## **RESPONSE TO THE COMMENTS FROM REFEREE 1**

## RESPONSE TO THE COMMENTS FROM REFEREE 2

**RESPONSE TO THE COMMENTS FROM JAMES OUIMETTE, 09 May 2024**

*Figure S5: Correlation between DP from PurpleAir and NOAA*

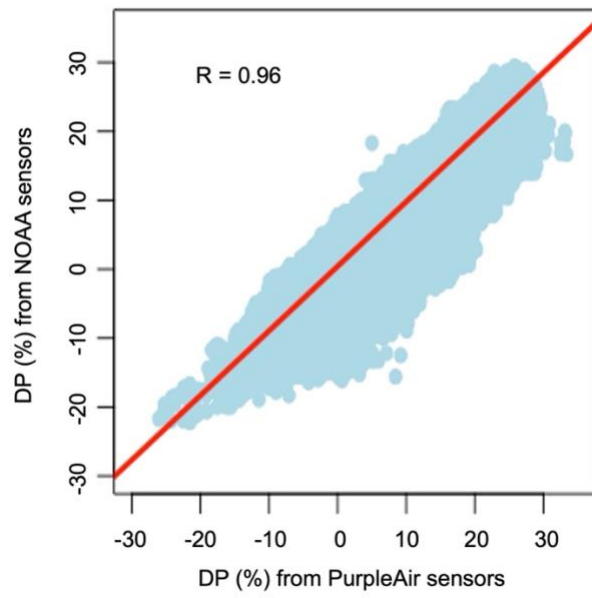
Your graphs comparing RH between the PurpleAir and its corresponding NOAA site is inadequate for assessing whether or not the NOAA site is representative. The best way to show if the PurpleAir and its corresponding NOAA site are sampling similar air is to compare their hourly average dew points. That's because the PurpleAir slightly heats the air sample, resulting in a higher temperature and lower RH compared to the NOAA site. However, the water content and dew point should be the same for the PurpleAir and the NOAA site.

Could you please provide graphs comparing the hourly average dew points for your 21 sites.

**Response:** Thank you for the comment. We included a comparison section between DP from NOAA sites and PurpleAir in the Supplemental Information (Fig. S5, see below) and referenced in line 406. However, we wanted to point out that DP was excluded from our study because DP exhibited correlation with both RH and T in the regression analysis when testing for variance inflation factor. A high correlation of 95% was found between DP and T. Therefore, including it would inflate the goodness of fit of the model.

*“After comparing NOAA and PurpleAir meteorological data (Fig. S5), we included ....” (line 406)*

*“To better estimate if NOAA meteorological data can replace PurpleAir meteorological data, we compared their DP since the water content and DP should be the same for the PurpleAir and the NOAA sites. Figure S5, which used all hourly datapoints of our study, showed a Pearson correlation of 96%. Except TX, which represented only 0.32% of our dataset and exhibited a low correlation (13%), all the NOAA sites resulted in a high correlation ranging from 80 to 97% with PurpleAir sites.” (Lines 127-131 of the Supplemental Information)*
